**NEW YORK STATE THRUWAY AUTHORITY  
DEPARTMENT OF ENGINEERING**

**AMENDMENT NO. 1  
TO**

**CONTRACT TAS 26-10A  
D215078  
PORT BYRON SERVICE AREA  
WATERMAIN REPLACEMENT  
AT I-90, MILEPOST 310.20  
IN THE SYRACUSE DIVISION  
OF THE NEW YORK STATE THRUWAY  
IN CAYUGA COUNTY**

**IN THE LETTING OF  
JANUARY 7, 2026**

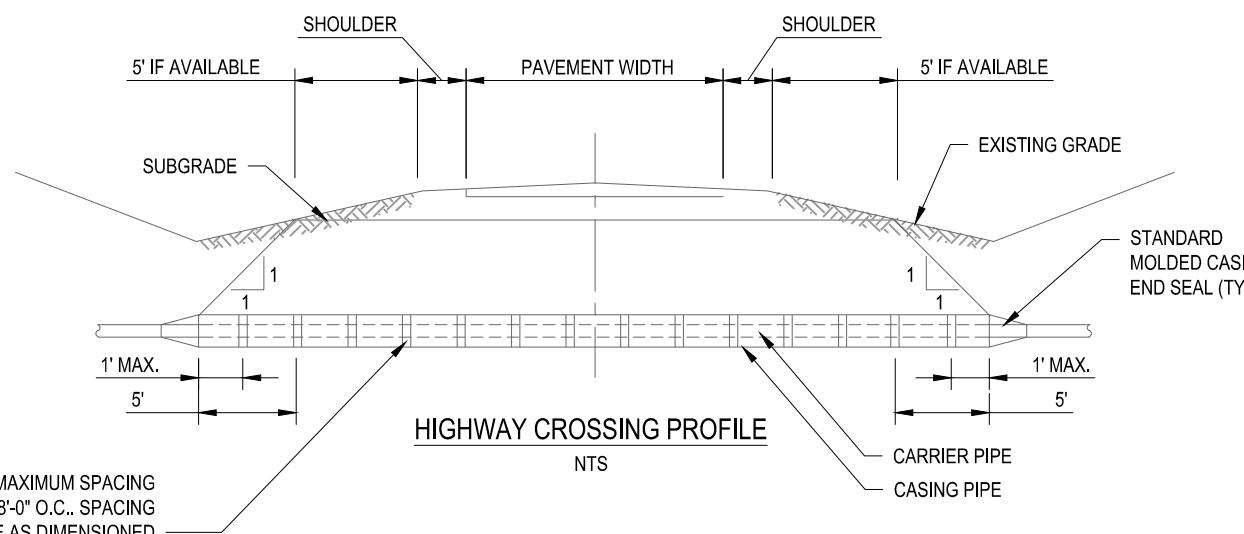
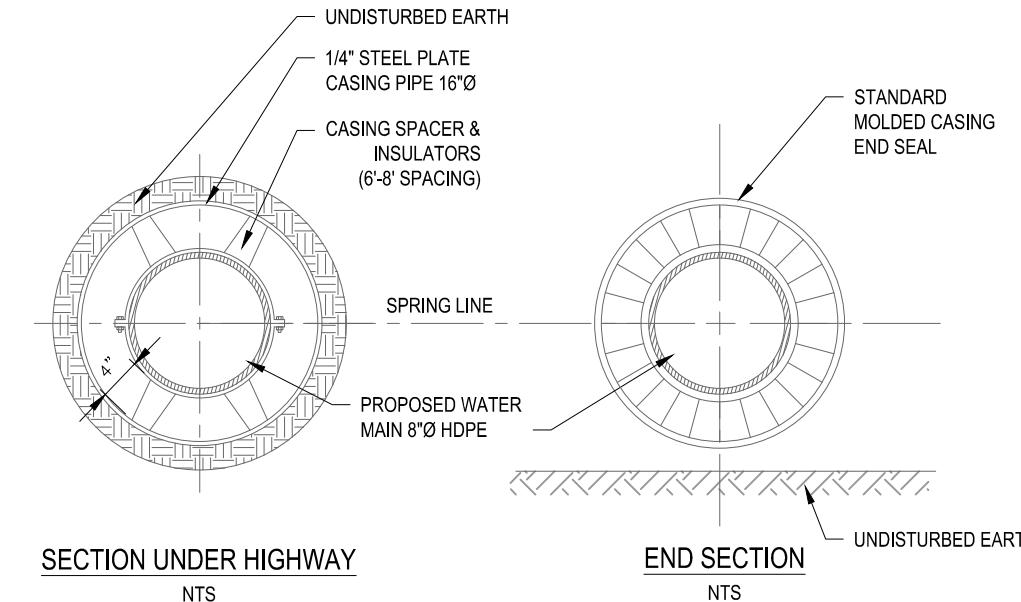
9. **DELETE** Drawing Number SD-06, Sheet 19 of 25 and **SUBSTITUTE** with the attached Drawing Number SD-06, Sheet 19-A1 of 25. Previous references to the proposed Ductile Iron Pipe (DIP) have been updated with HDPE (High Density Polyethylene), instead.

TITLE OF PROJECT WATER MAIN REPLACEMENT	CONTRACT NUMBER: TAS: 26-10A
LOCATION OF PROJECT PORT BYRON SERVICE AREA (MP 310.2)	DATE: 12/19/2025
TITLE OF DRAWING SITE DETAILS (8 OF 10)	DRAWING NUMBER: SD-08

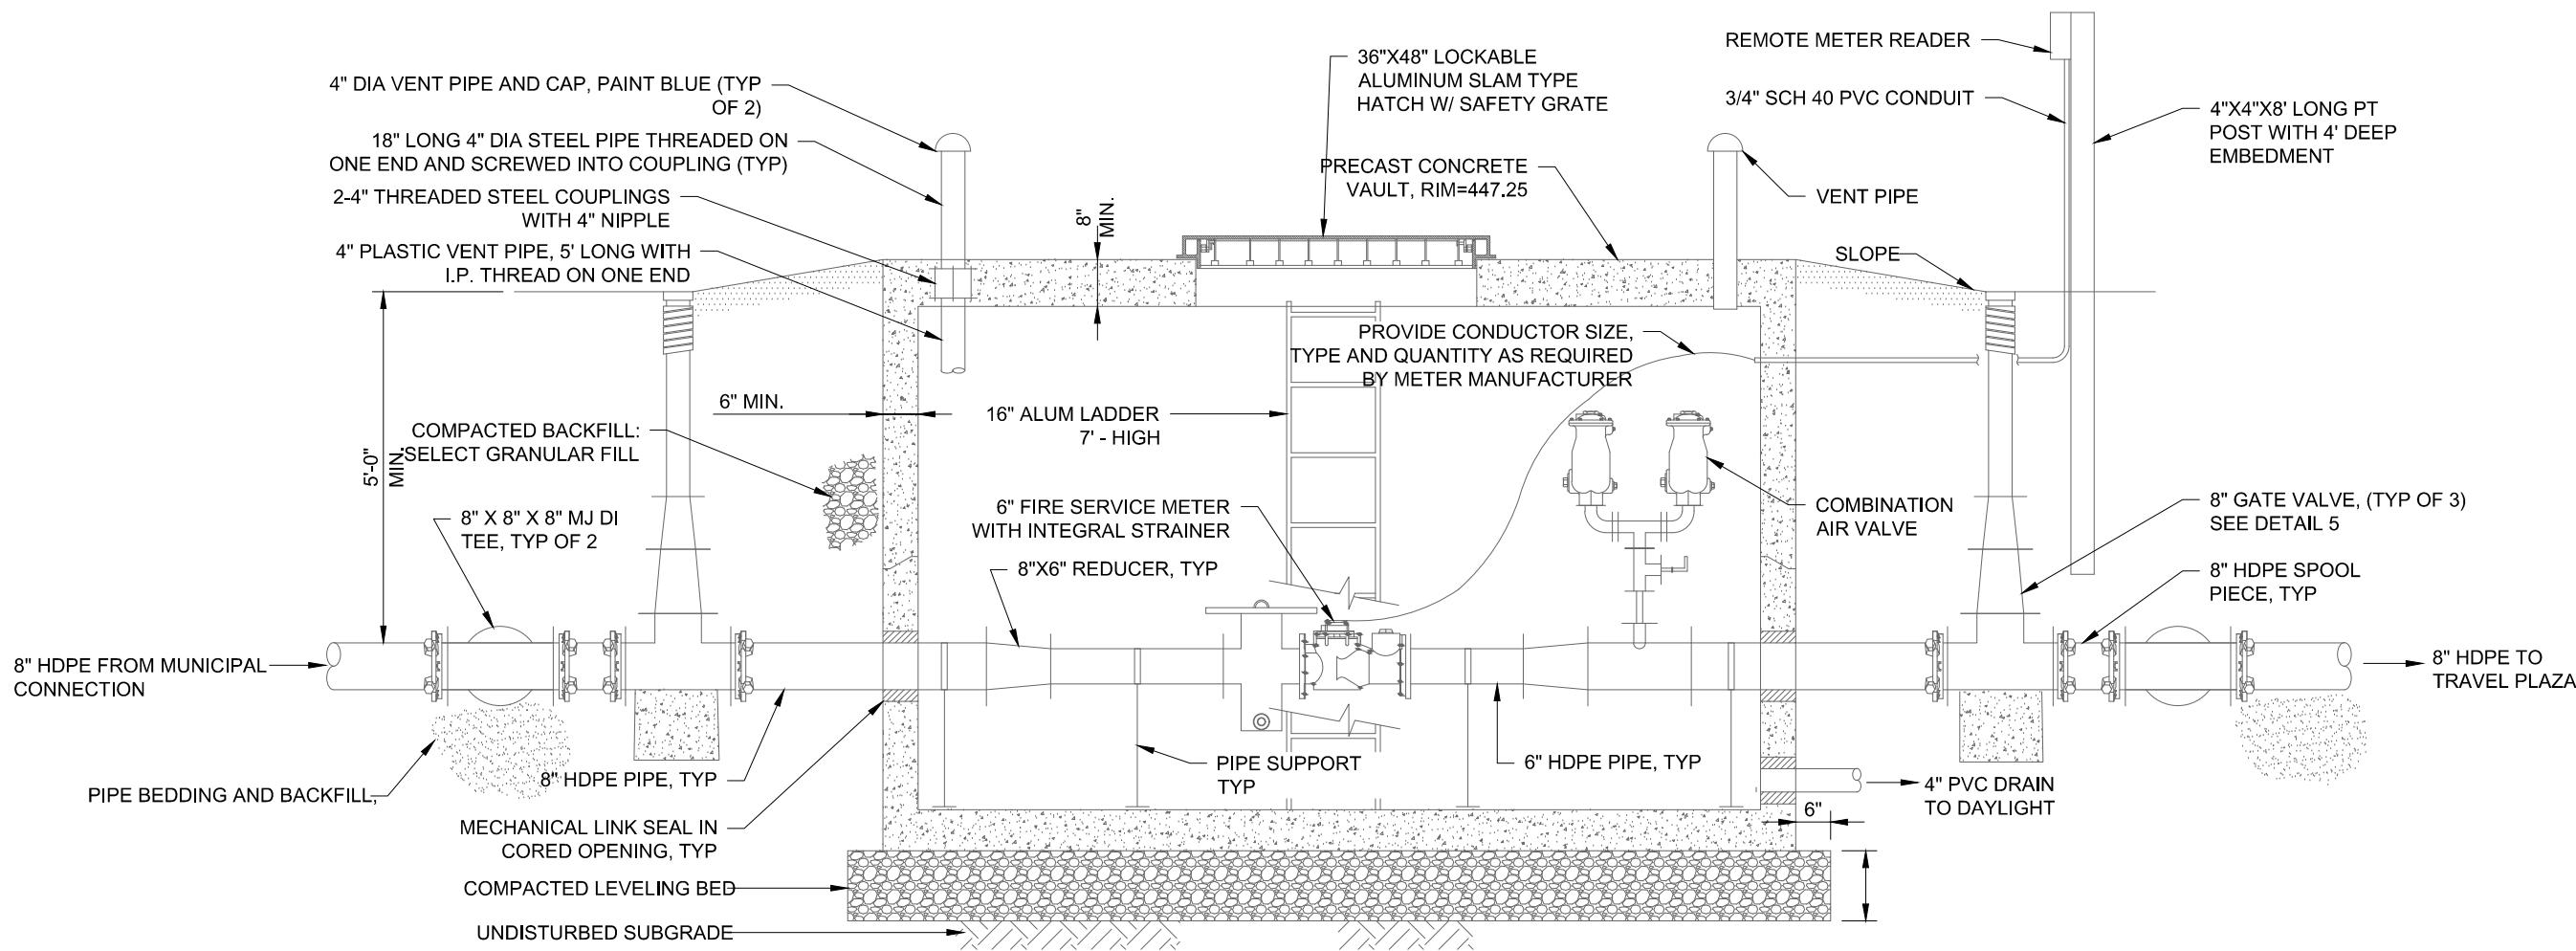
10. **DELETE** Drawing Number SD-08, Sheet 21 of 25 and **SUBSTITUTE** with the attached Drawing Number SD-08, Sheet 21-A1 of 25. Previous references to the proposed Ductile Iron Pipe (DIP) have been updated with HDPE (High Density Polyethylene), instead.

TITLE OF PROJECT	WATER MAIN REPLACEMENT	CONTRACT NUMBER:
LOCATION OF PROJECT	PORT BYRON SERVICE AREA (MP 310.2)	TAS: 26-10A
TITLE OF DRAWING	12/19/2025	DATE:
SITE DETAILS	(9 OF 10)	DRAWING NUMBER:

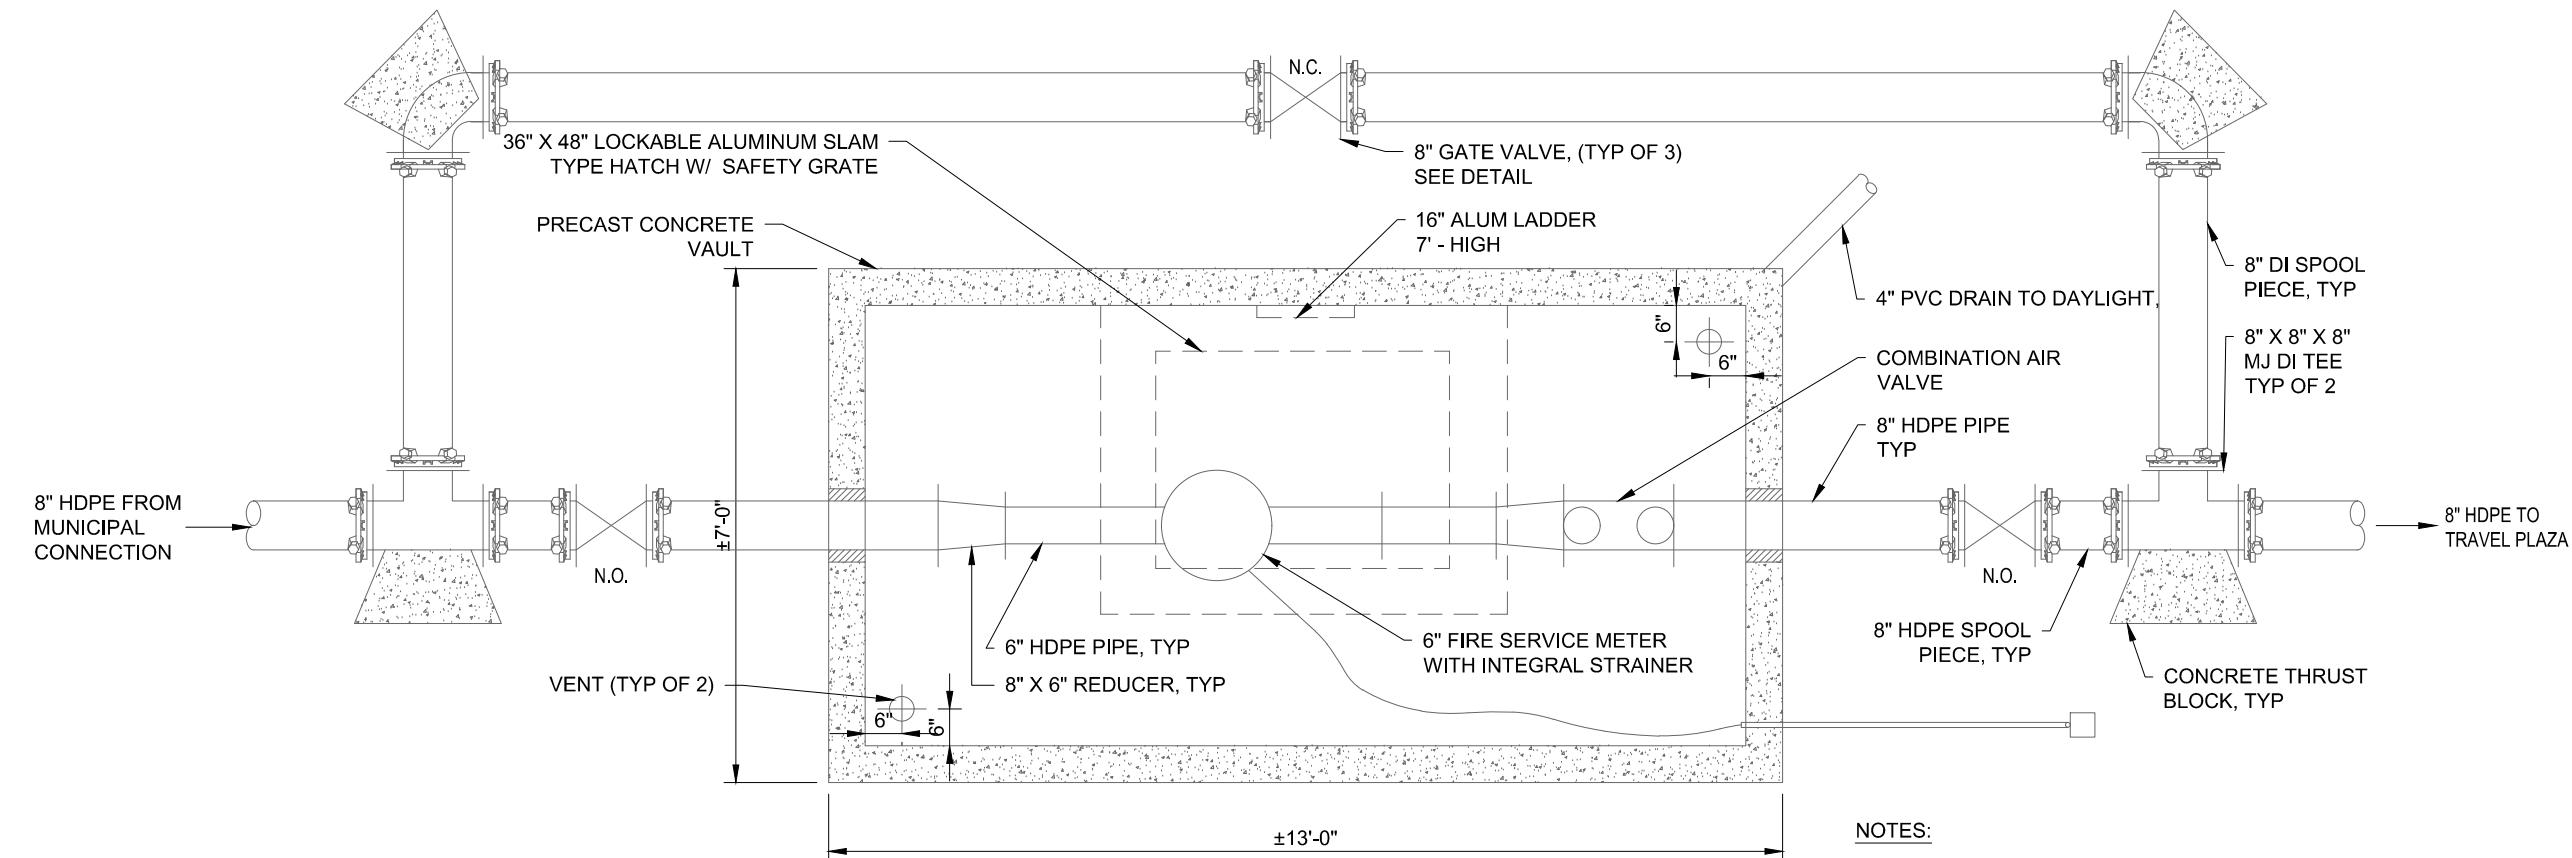
11. **DELETE** Drawing Number SD-09, Sheet 22 of 25 and **SUBSTITUTE** with the attached Drawing Number SD-09, Sheet 22-A1 of 25. Previous references to the proposed Ductile Iron Pipe (DIP) have been updated with HDPE (High Density Polyethylene), instead.
